G.1.a.j 1326 Pandora Avenue: Rezoning Application No. 00767 and Development Permit with Variances Application No. 000594 (Fernwood)

Committee of the Whole Report For the Meeting of June 29, 2023

Subject: **Rezoning Application No. 00767 and Development Permit with Variances Application No. 000594 for 1326 Pandora Avenue**

L1 Landscape Site Plan

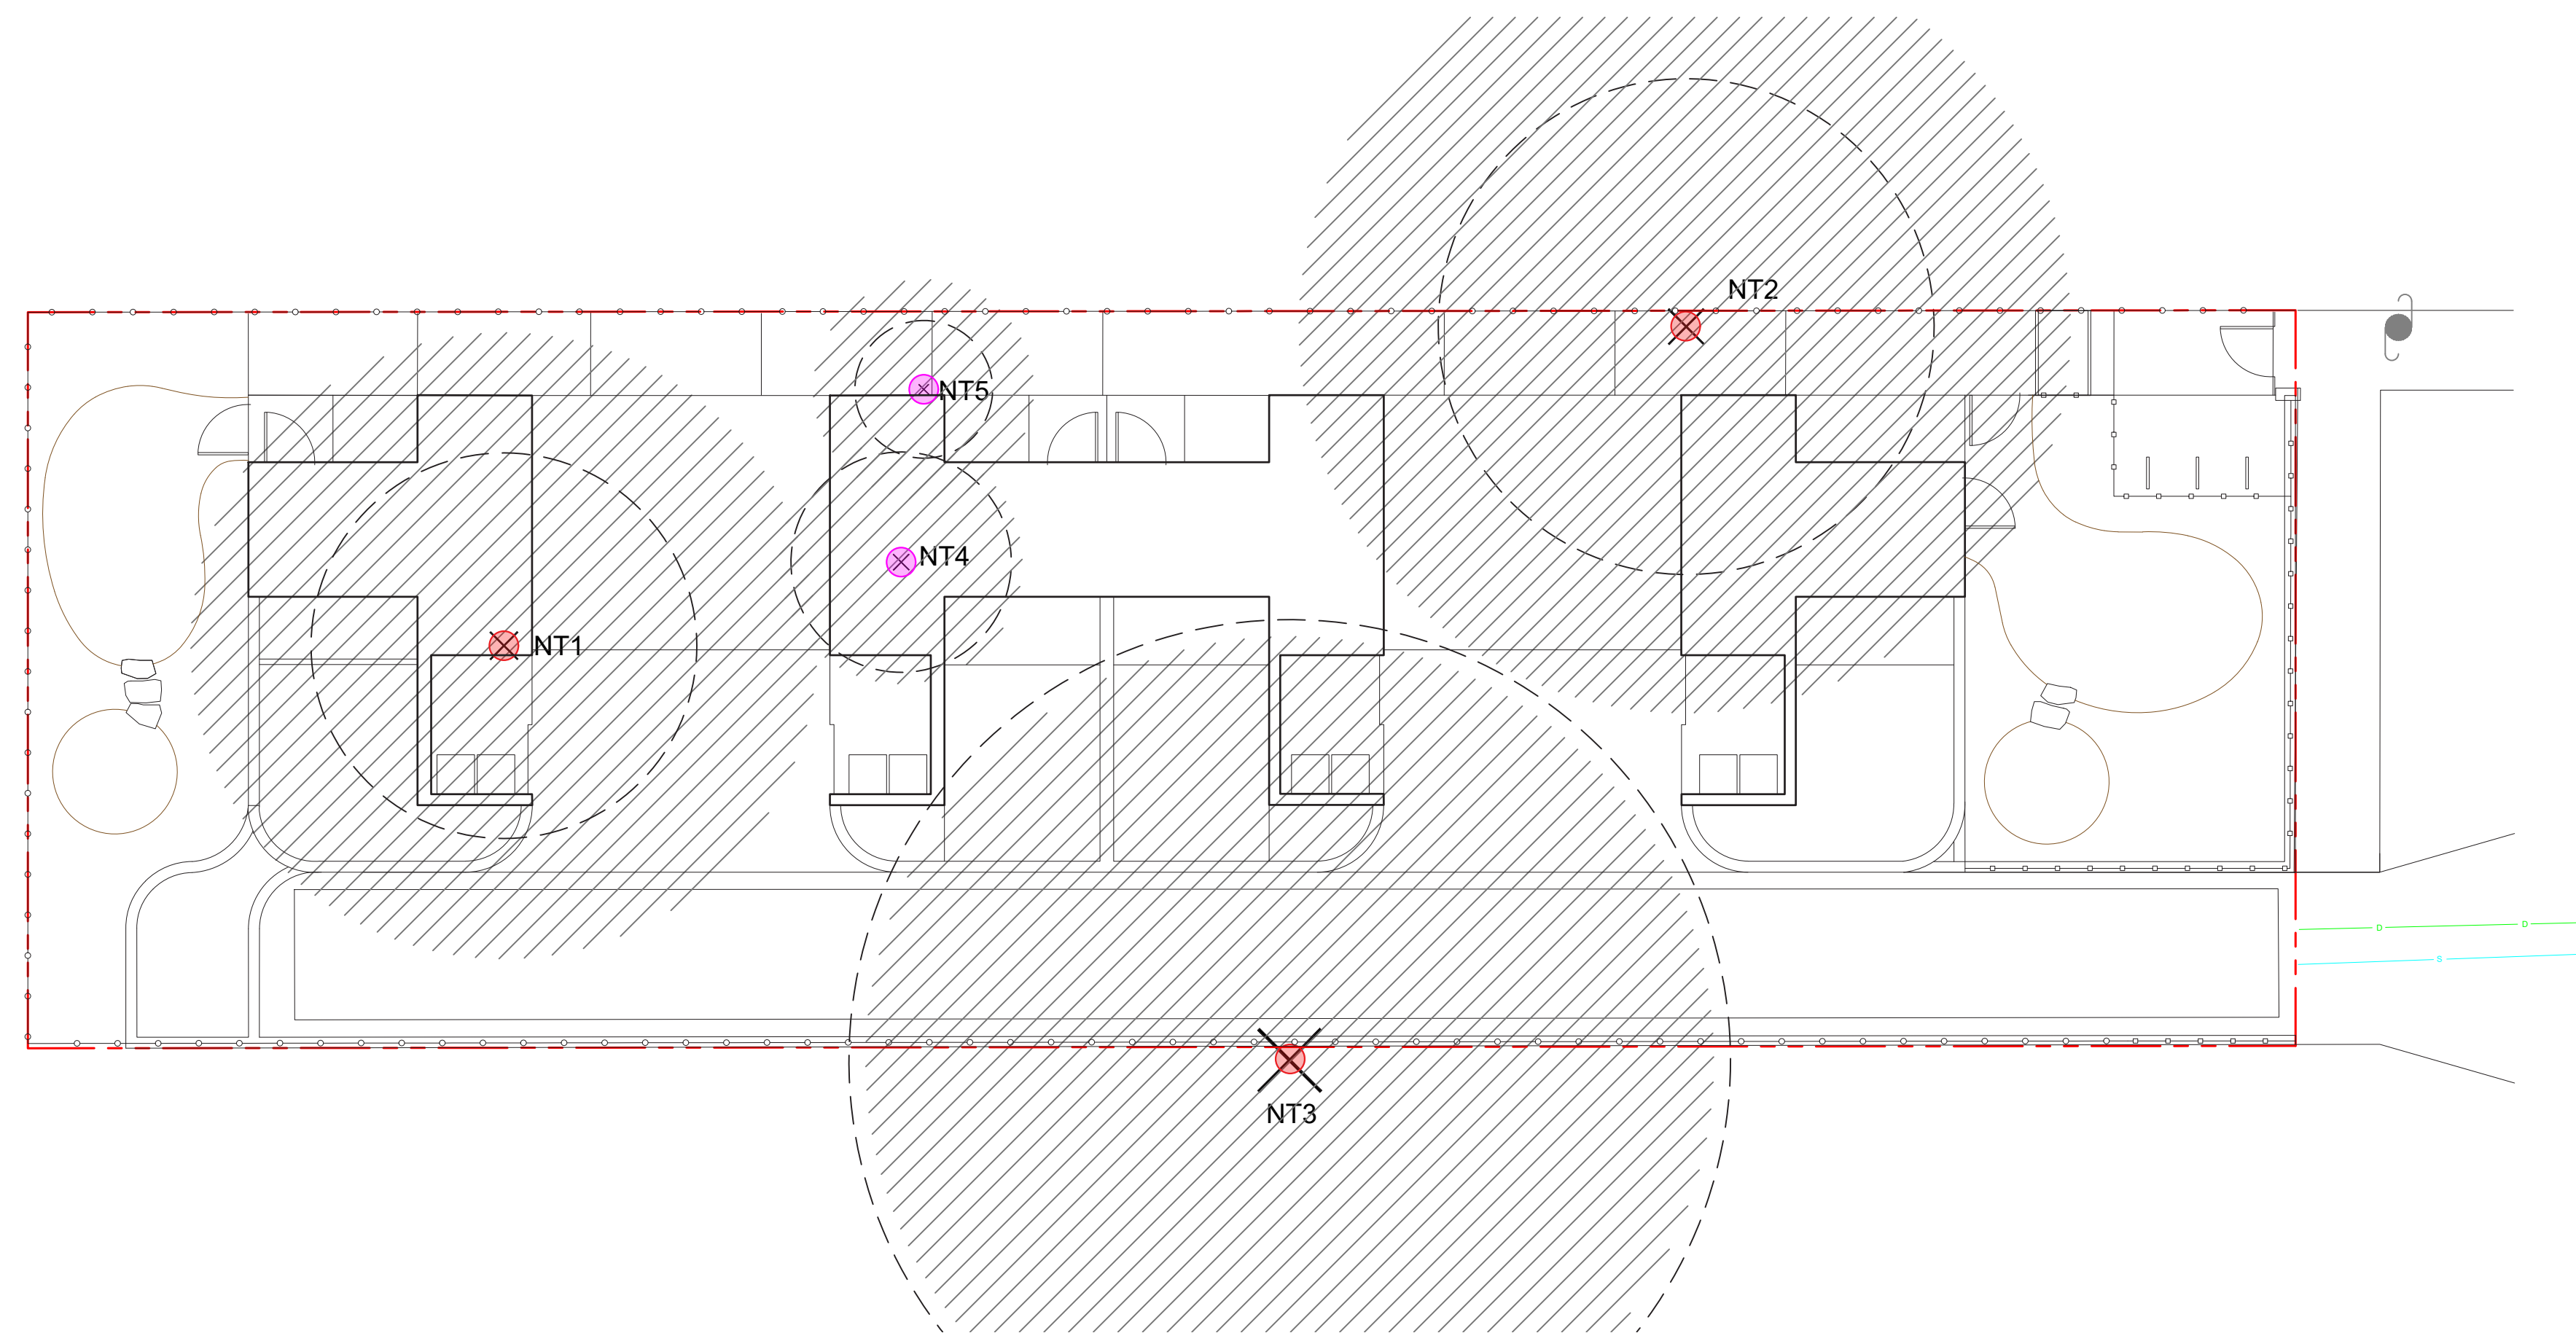
- i. retention of tree NT2, or;
 - ii. or if tree NT2 is to be removed, clarification regarding ownership of the tree and updated plans and documentation to meet the Tree Protection Bylaw

- v. Removal of cedar fence from future site triangles
 - vi. Designation of two additional trees as replacement trees.
2. That first and second reading of the zoning bylaw amendment be considered by Council and a public hearing date be set once the above conditions are met.

1326 PANDORA AVE
PRELIMINARY SITE
SERVICING PLAN

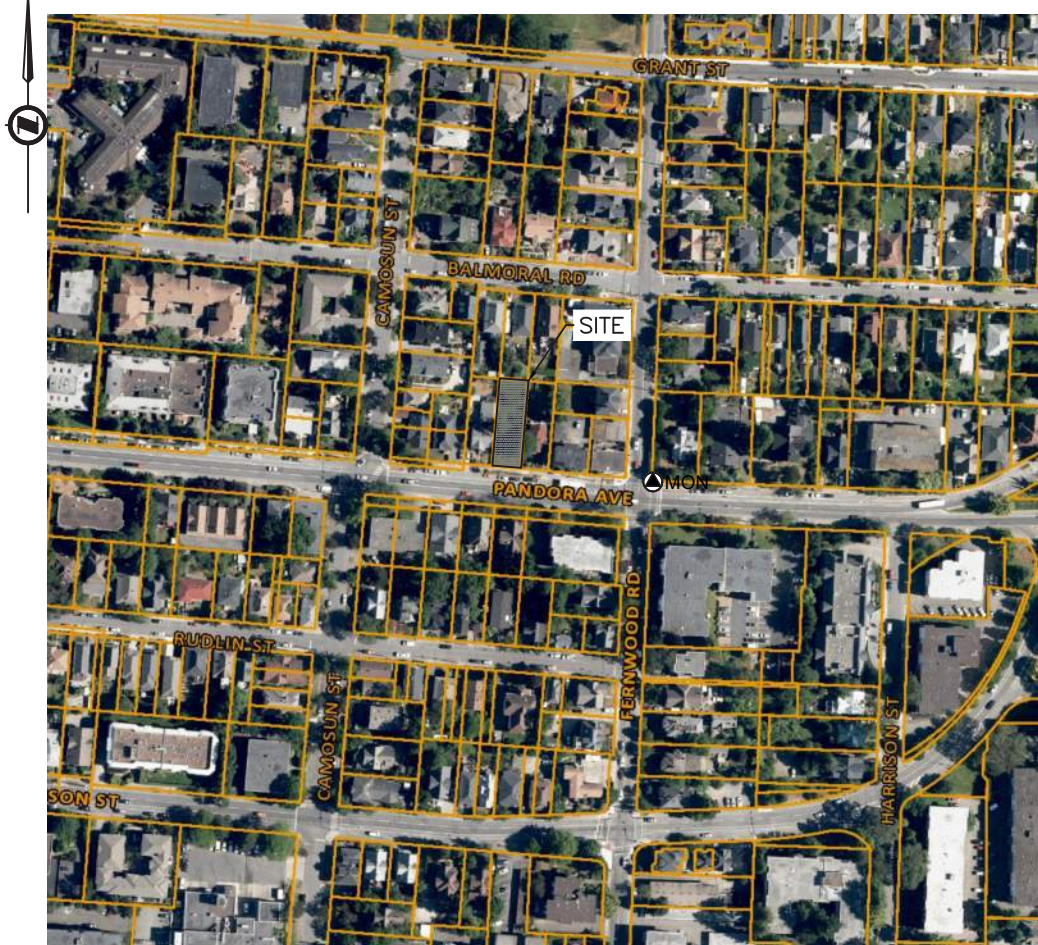
- iii. Inclusion of proposed municipal tree on civil drawings
 - iv. Site servicing plan showing
 - a. Hardscape surfaces and treatments
 - b. Utility services: sanitary sewer, storm drain, water, gas, BC Hydro, and telecommunications

- iii. Inclusion of proposed municipal tree on civil drawings
 - iv. Site servicing plan showing
 - a. Hardscape surfaces and treatments
 - b. Utility services: sanitary sewer, storm drain, water, gas, BC Hydro, and telecommunications
